POINT BEACH NUCLEAR PLANT, UNIT NO. 1

ATTACHMENT TO LICENSE AMENDMENT NO. 14  
CHANGE NO. 19 TO THE TECHNICAL SPECIFICATIONS

Replace page 15.2.1-1, page 15.2.1-3, Figure 15.2-1-1, page 15.2.3-2, page 15.3.3-2, pages 15.3.10-2 through 15.3.10-13, Figure 15.3.10-1, and Figure 15.3.10-3 with the attached revised pages. Add page 15.3.3-2a, page 15.3.10-14, and page 15.3.10-15.

SAFETY EVALUATION BY THE OFFICE OF NUCLEAR REACTOR REGULATION  
SUPPORTING AMENDMENTS NOS. 14 AND 18 TO LICENSES DPR-24/27  
(CHANGE NOS. 19 AND 24 TO THE TECHNICAL SPECIFICATIONS)

Figure 15.2.1-1 Core DNBS Safety Limits  
Point Beach 1

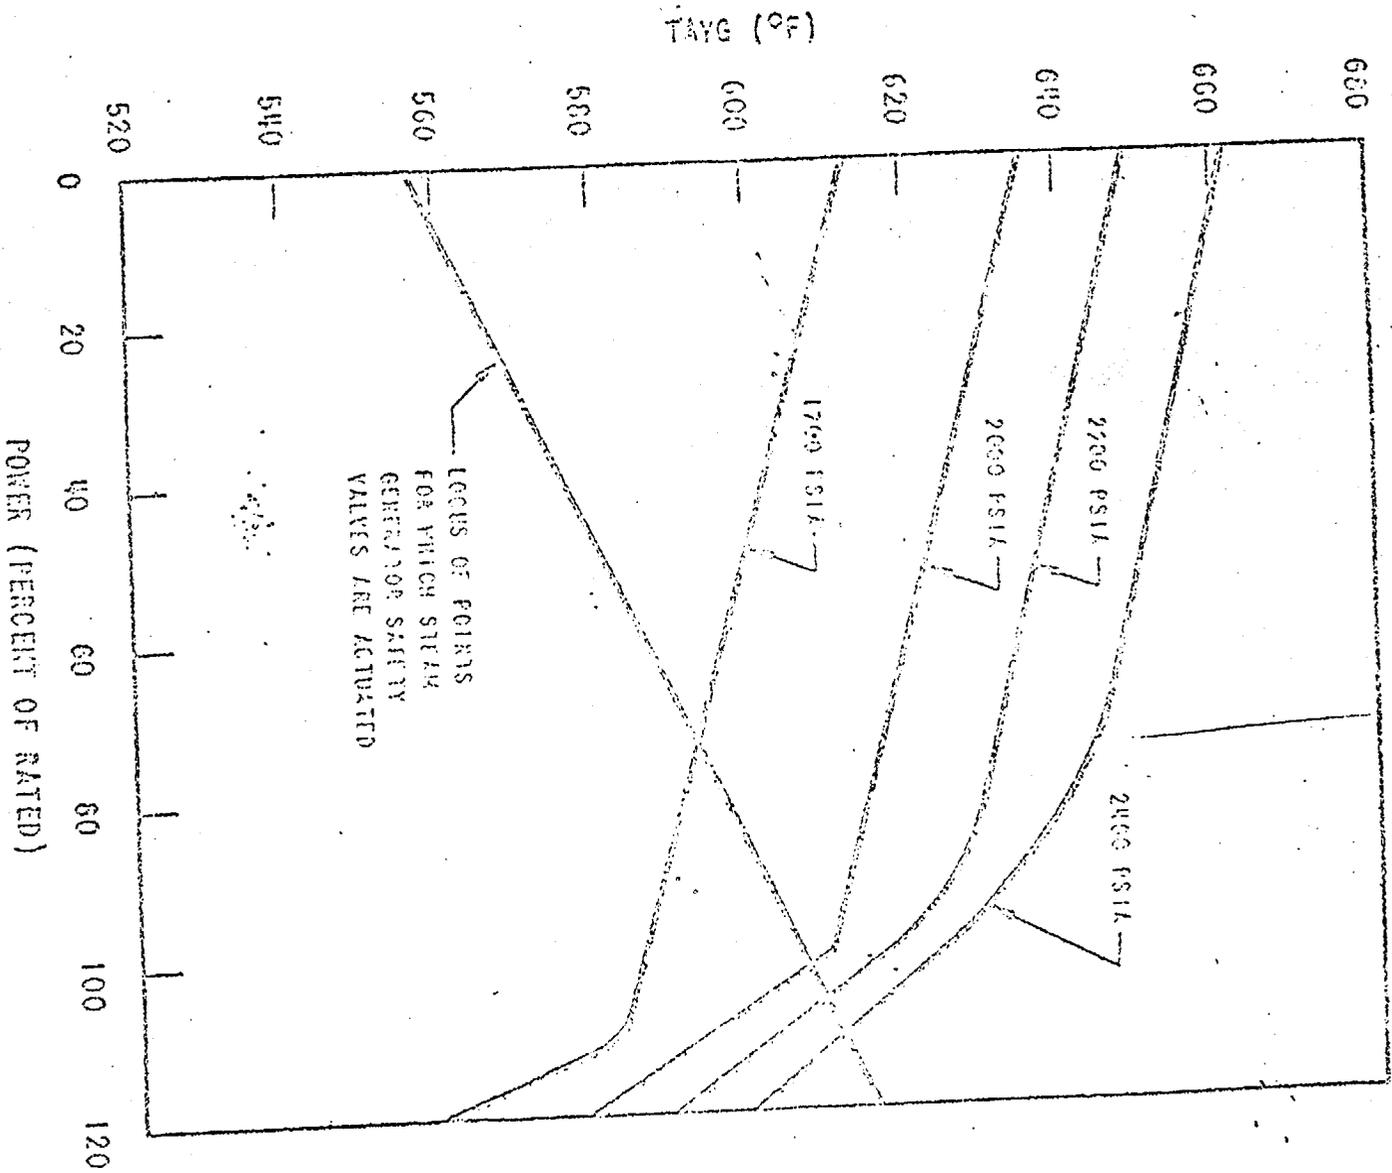
Additional peaking factors account for local peaking due to fuel rod axial gaps and reduction in fuel pellet stack length as well as a penalty to account for rod bowing, have been included in the calculation of the curves shown in Figure 15.2. These curves are based on an  $F_{\Delta H}^{II}$  of 1.58, cosine axial flux shape, and a DNB analysis as described in Section 4.3 of WCAP-8050 "Fuel Densification, Point Beach Nuclear Plant Unit 1 Cycle 2", (including the effects of fuel densification and flattened cladding).

Figure 15.2.1-1 also includes an allowance for an increase in the enthalpy rise hot channel factor at reduced power based on the expression:

$$F_{\Delta H}^{II} = 1.58 [1 + 0.2 (1-P)] \text{ where } P \text{ is a fraction of rated power}$$

when  $P \leq 1.0$ .  $F_{\Delta H}^{II} = 1.58$  when  $P > 1.0$ .

An additional rod bow penalty is applied for the Point Beach Unit 1 core Cycle 4 to limit the radial peaking factor  $F_{\Delta H}^{II}$  to a more conservative value of 1.55 instead of 1.58. This additional penalty is based on new data (plus appropriate conservatism) which shows that the bowing model in WCAP-8386, "An Evaluation of Fuel Rod Bowing" underestimates the extent of fuel rod bowing.

FIGURE 15.2.10-3

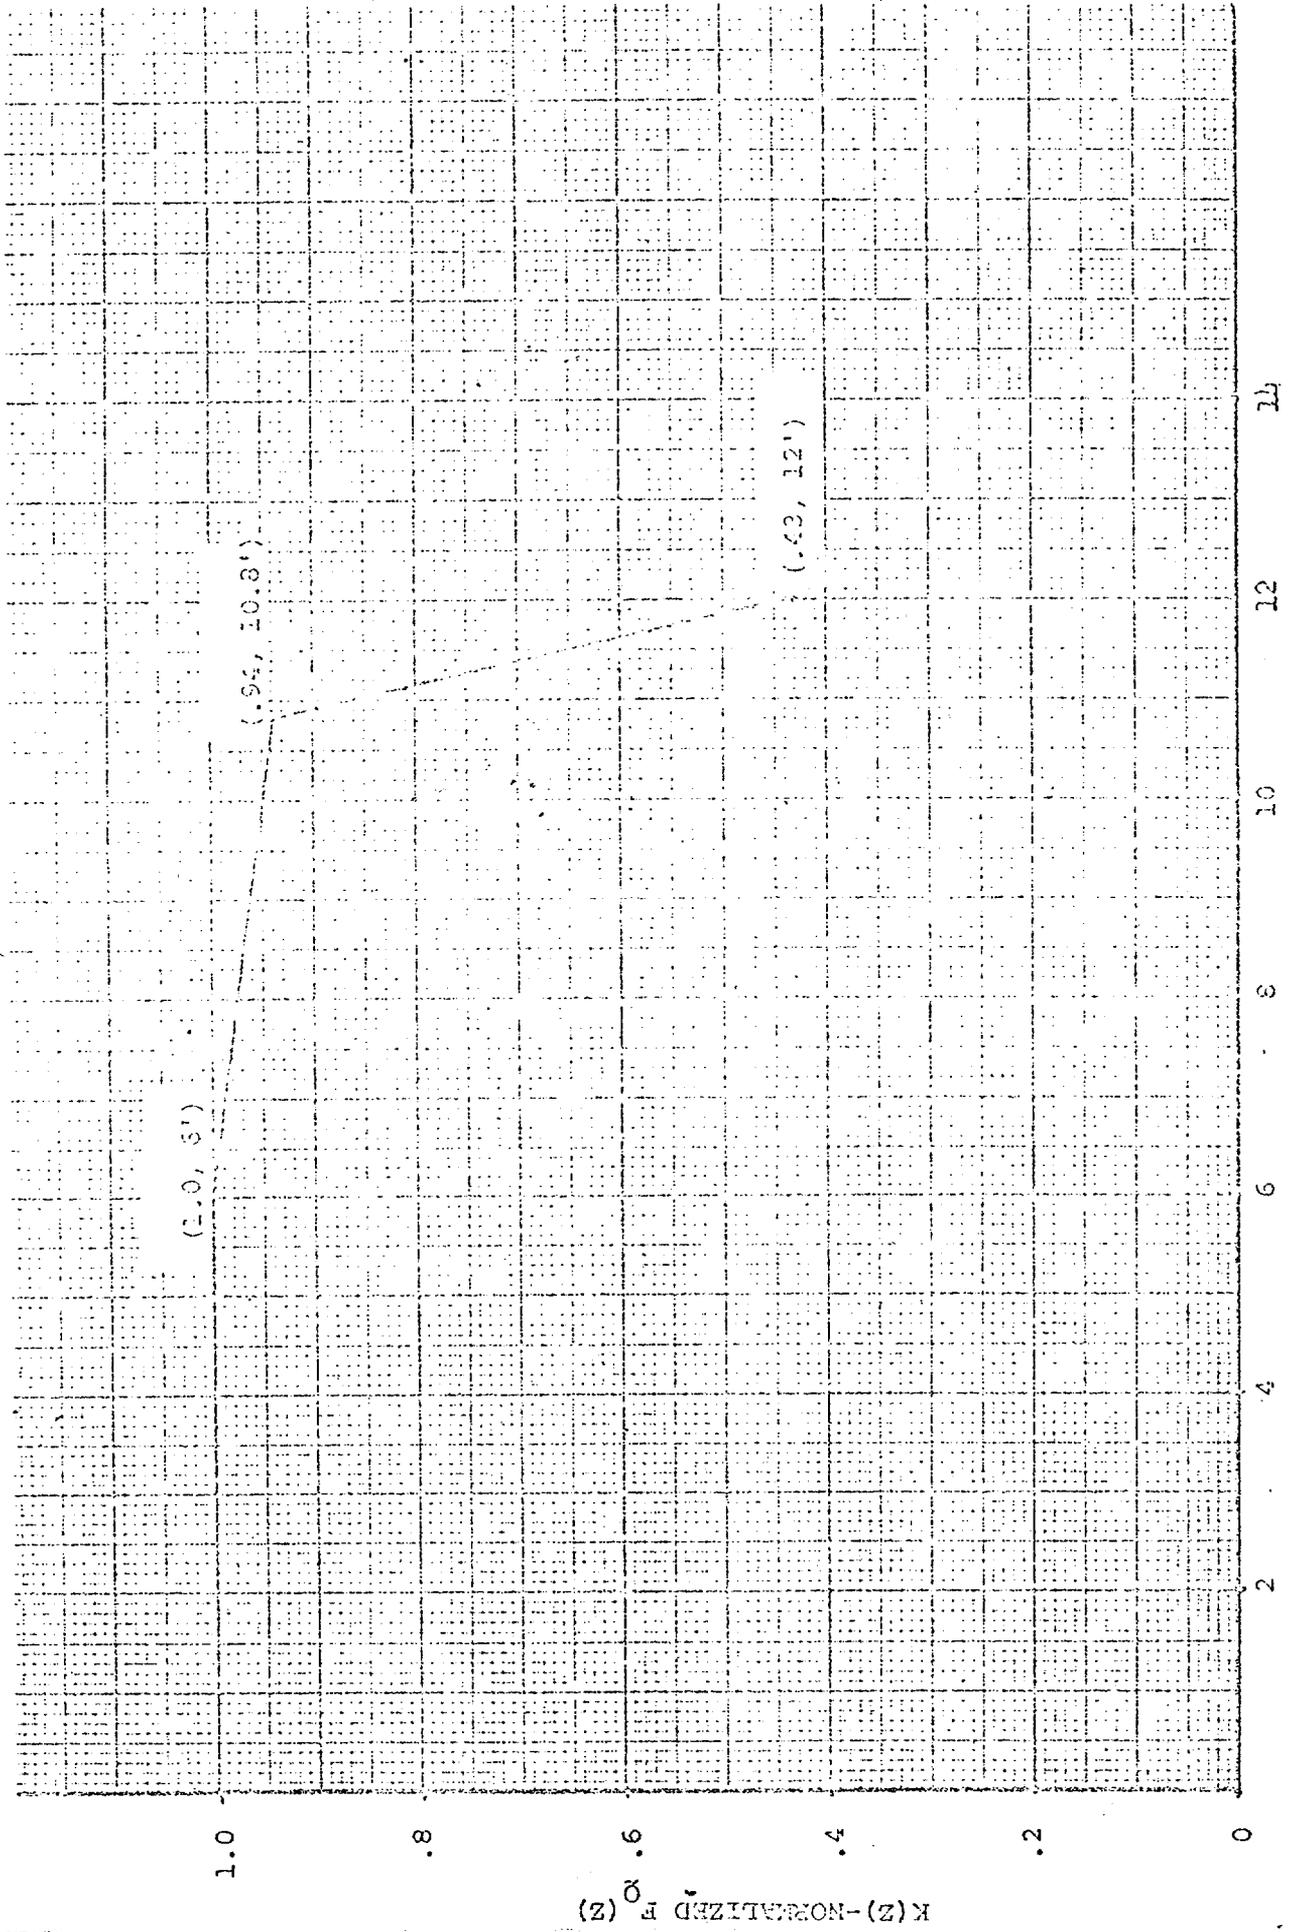
where P is the fraction of full power at which the core is operating, K(Z) is the function in Figure 15.3.10-3 and Z is the core height location of F<sub>Q</sub>.

An upper bound envelope of 2.32 times the normalized peaking factor axial dependence of figure 15.3.10-3 consistent with the Technical Specifications on power distribution control as given in section 15.3.10 was used in the LOCA analysis. The results of the analyses based on this upper bound envelope indicate a peak clad temperature of 1996°F corresponding to a 2040°F margin to the 2200°F limit.

FIGURE 15.3.10-3

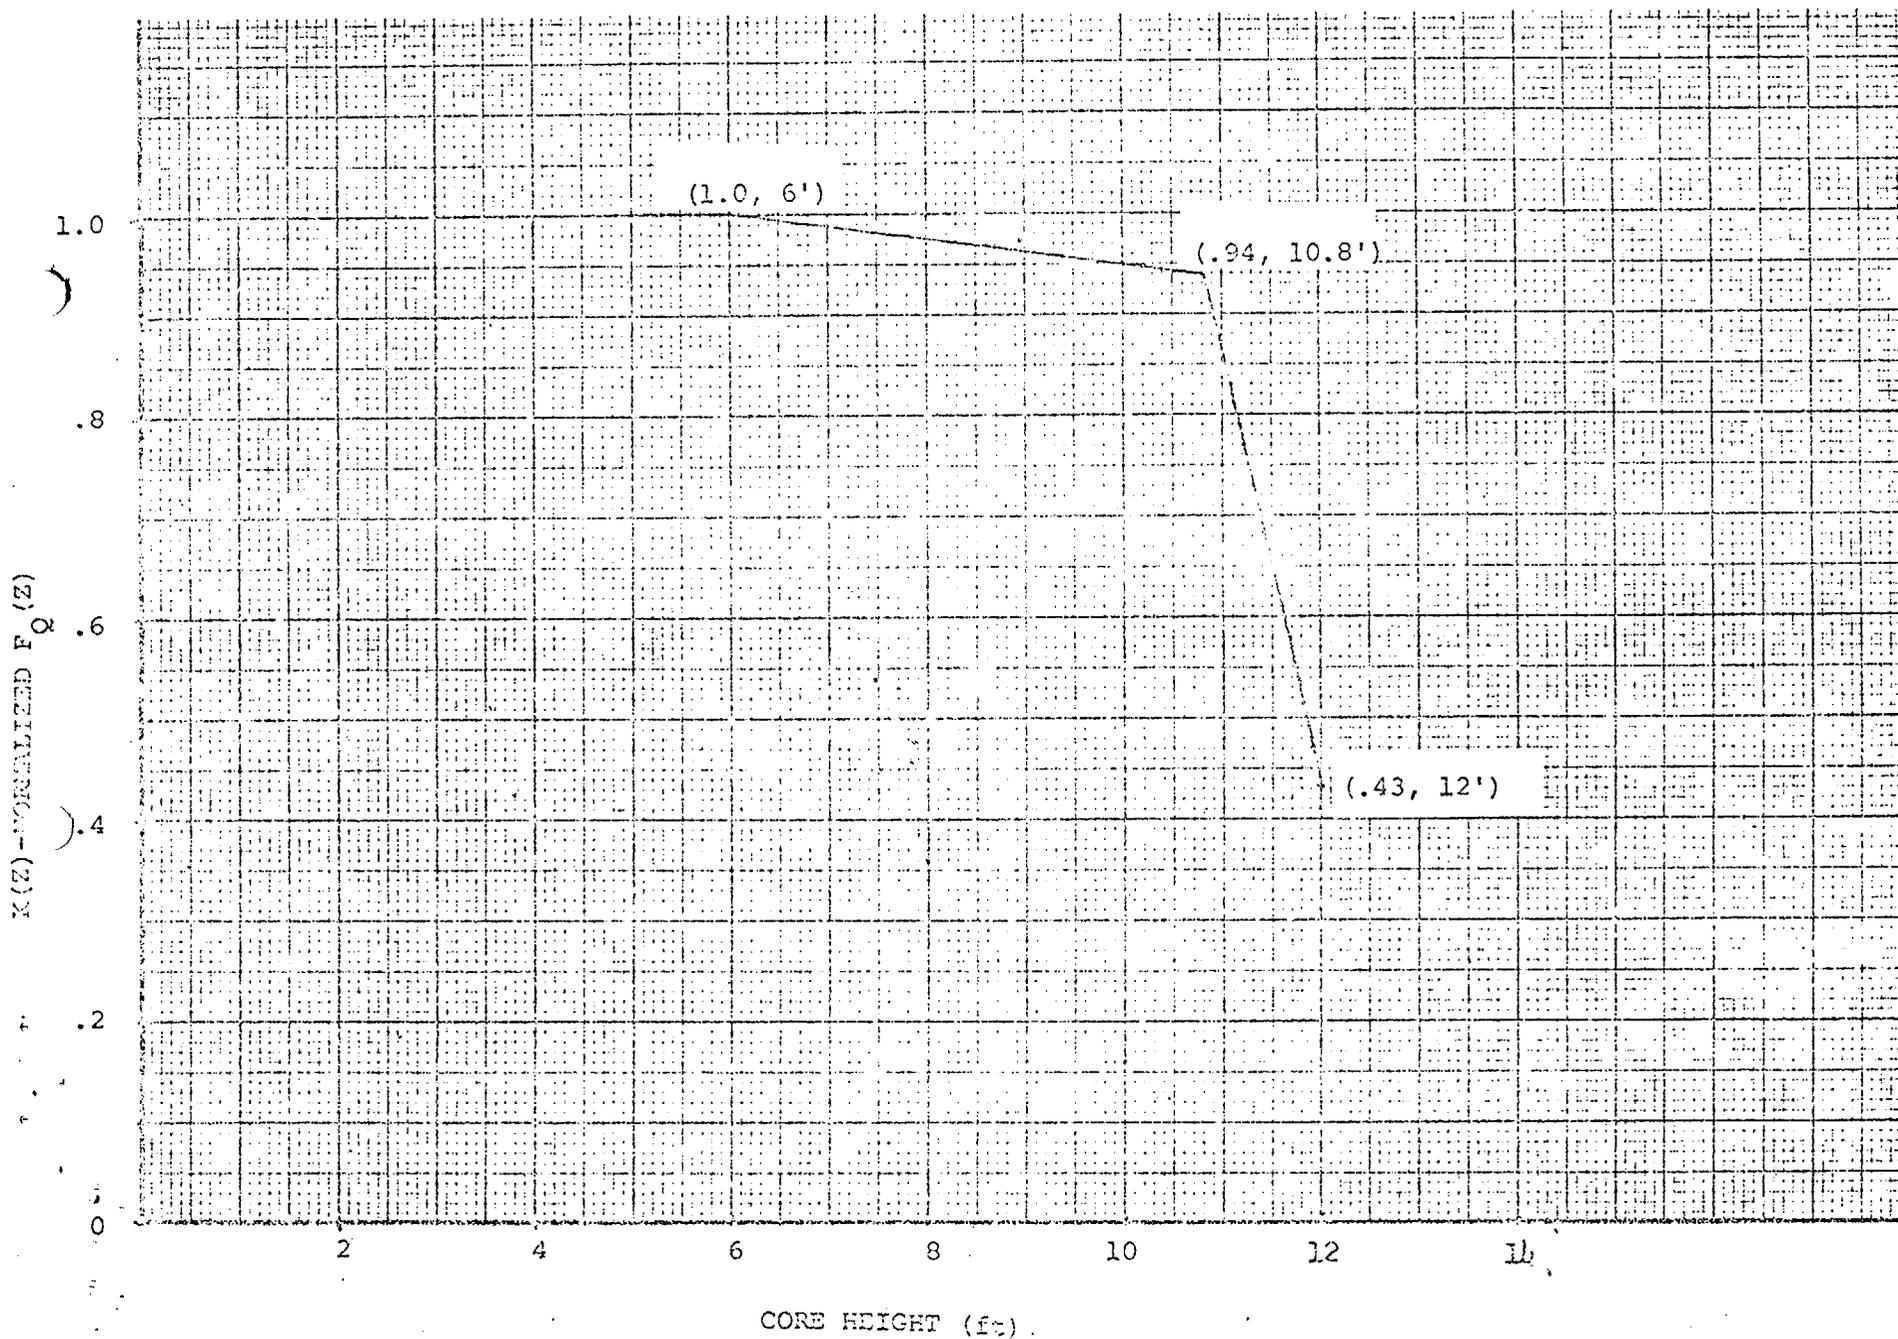
where P is the fraction of full power at which the core is operating, K(Z) is the function in Figure 15.3.10-3 and Z is the core height location of F<sub>Q</sub>.

An upper bound envelope of 2.32 times the normalized peaking factor axial dependence of figure 15.3.10-3 consistent with the Technical Specifications on power distribution control as given in section 15.3.10 was used in the LOCA analysis. The results of the analyses based on this upper bound envelope indicate a peak clad temperature of 1996°F corresponding to a 2040°F margin to the 2200°F limit.
